Concerns with stressed input tests in
Annex 120E D3p2
(Direct reference from Annex 135G)

June 2016

Step response, without and with channel

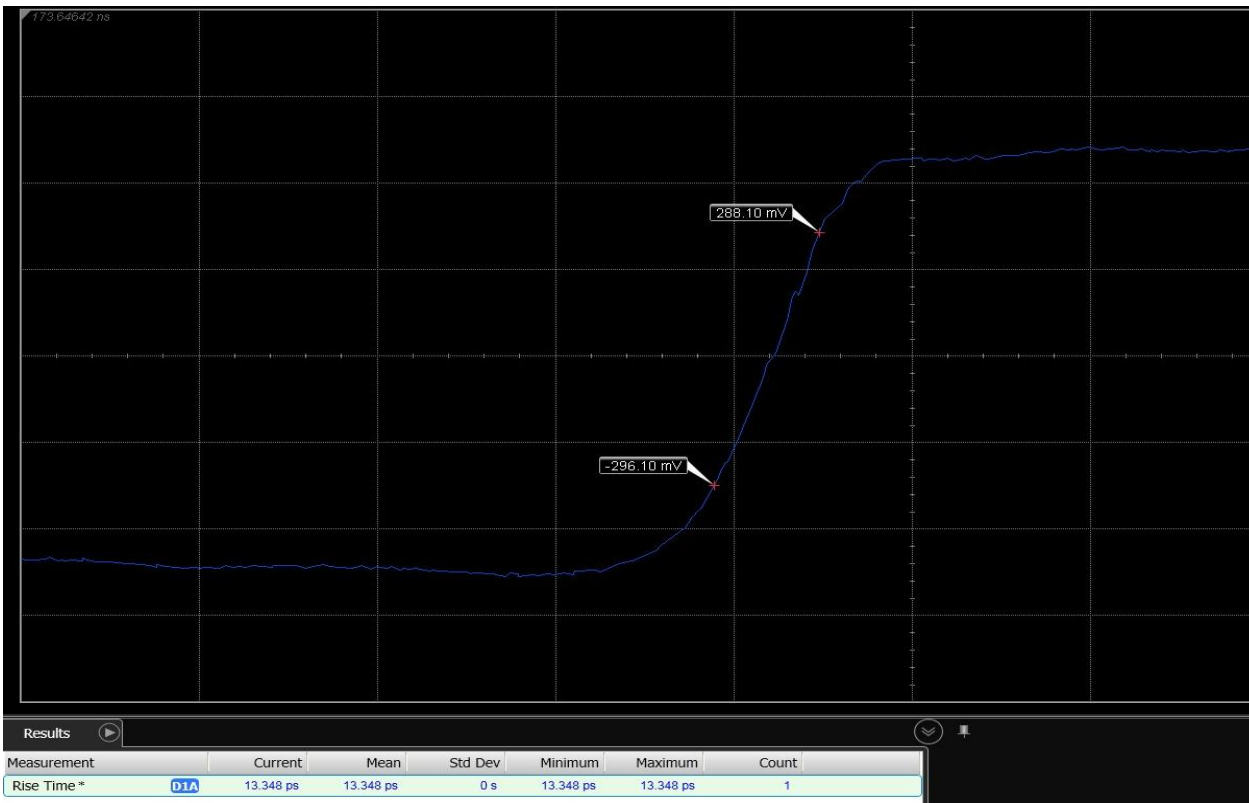
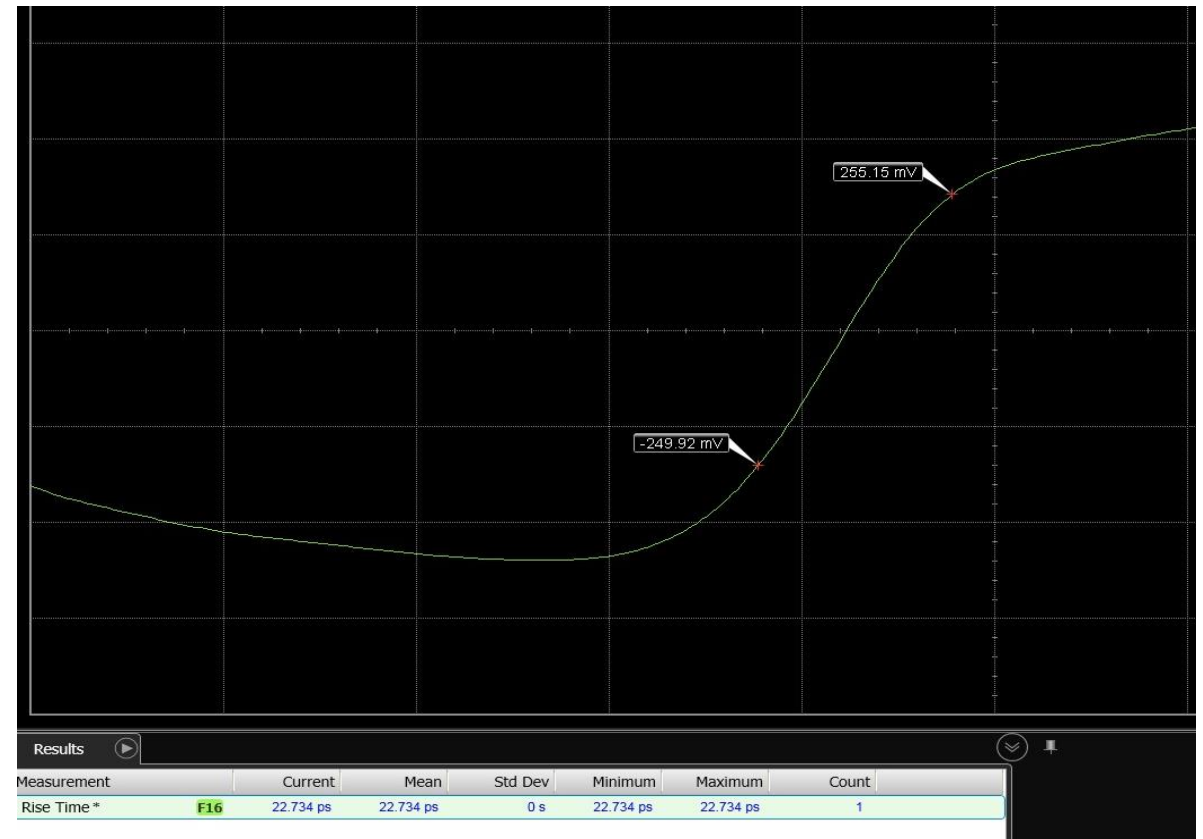
PG output: ≈ 12 ps De-Emphasis is used, but has little effect after channel

Tr (20-80%) = 13.48 ps

Tr (20-80%) = 22.73 ps

- Channel loss combined with measurement instrument BW considerably slow transition
- 12 ps measured as above would equate to an unrealistically fast host or module driver output
- Aggressor transition time when measured as specified using practical test equipment is nearly twice the specified value
- Recommend changing parameter limit to value that more accurately equates to actual host or module driver
-or- add text stating that practical test equipment will likely not achieve specified transition time

Eye , with aggressor

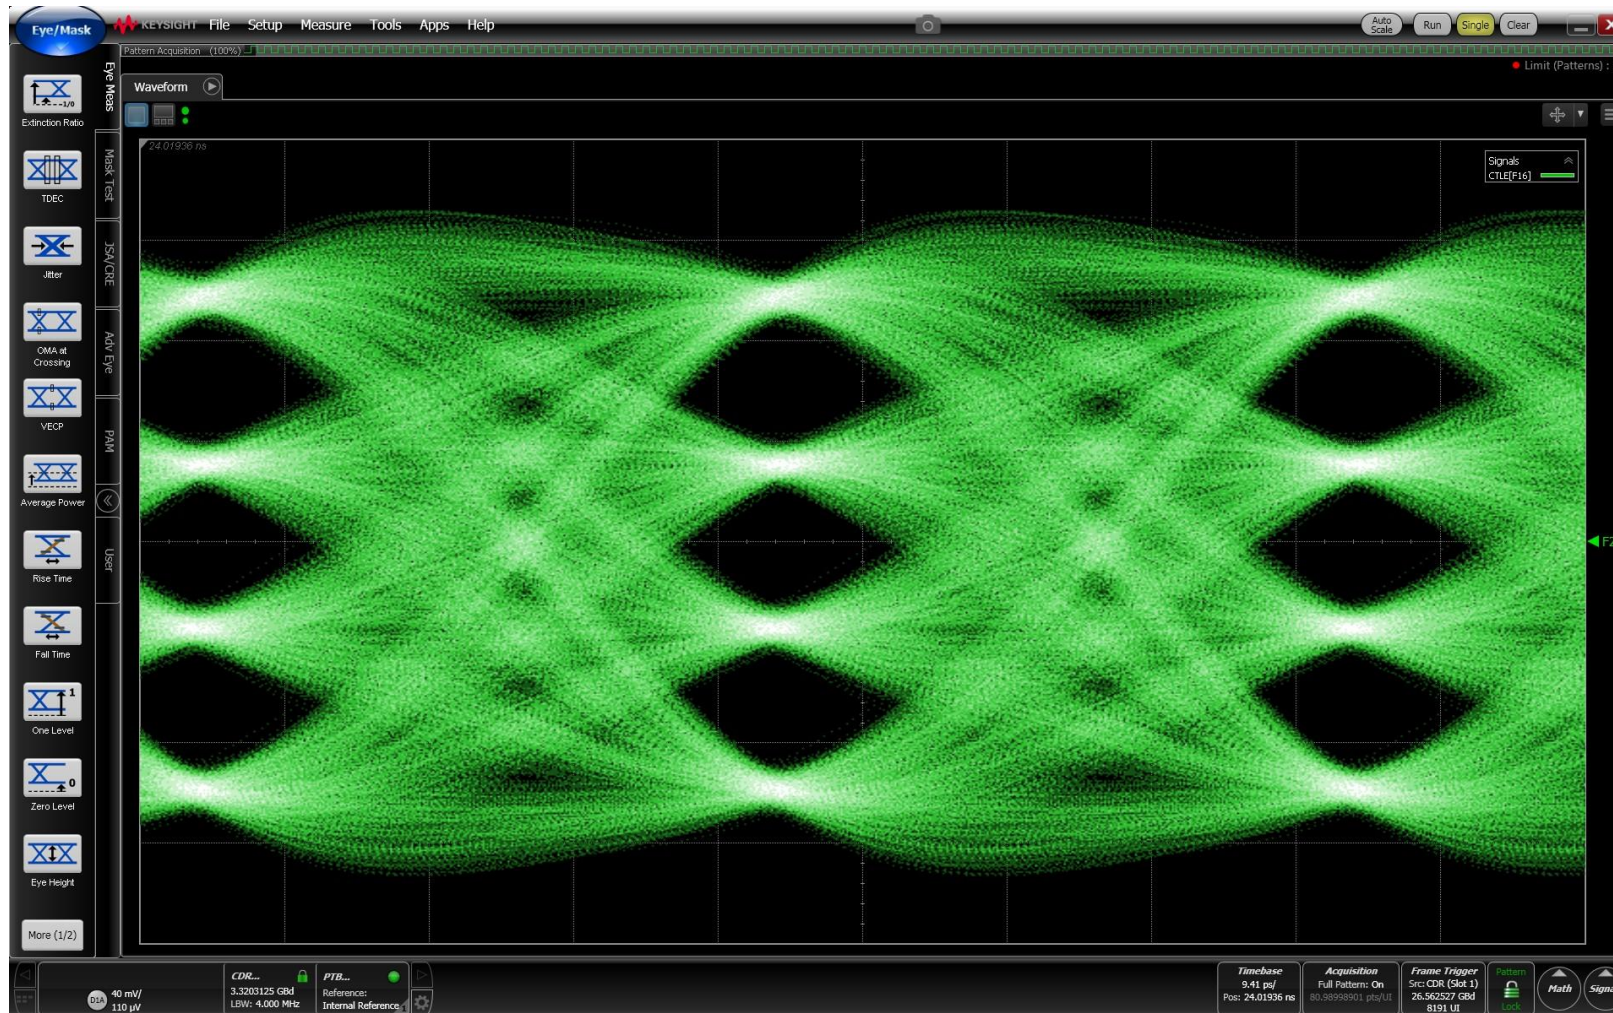
- Preliminary work shows eye width is narrower than specified (0.20 UI) for stressed host and module input tests when measured through compliance channel
- Residual jitter is not the issue – it's mostly all loss in the test channel (HCB / MCB)

- Using specified test setup with high performance commercially available test equipment, stressed test pattern eye width and eye height fail to meet requirement
- CTLE (in reference receiver) peaked at Nyquist provides little boost for 3rd harmonic. This generates a sinusoidal eye – OK for NRZ, but provides inadequate opening for upper and lower eyes in PAM4.

Question – is using a reference receiver CTLE peaked at Nyquist really similar to actual receiver BW and CTLE response?
